Jason and Ann Gregorek

1715 Wood Avenue

A Report of Acceptability Application for a 30 square feet addition on the east elevation and the removal of two (2) center patio columns of the south elevation of the existing residence.

File Number	Application Type	Decision Type
HIST-25-0001	Report of Acceptability	Quasi-Judicial

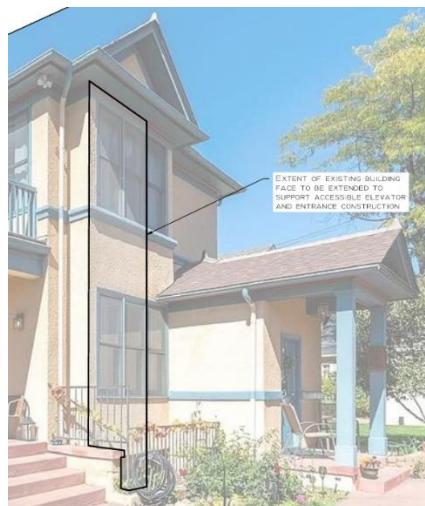
The Applicant has submitted a Report of Acceptability for a 30 square feet addition to the east elevation of the main home located at 1715 Wood Avenue (see **“Attachment 3-Project Statement”** and **“Attachment 4-Architectural Plans”**). The addition is to accommodate an elevator lift system for a resident of the home with a disability. The new addition and elevator will provide improved and easier access for this family member to the home’s multiple levels. The elevator footprint occupies the space of the existing egress window well on the back of the home next to the rear entryway (see **“Attachment 5-Aerial Map”**). The exterior finishes are scheduled to match existing details of the house to meet adopted design standards.

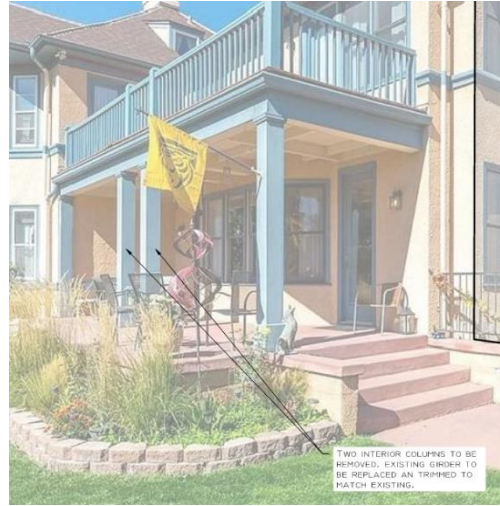
A secondary element of this project is the removal of the center two (2) patio columns on the south elevation to create an open view of the side yard from the patio. This work is also scheduled to match the existing details of the residence.
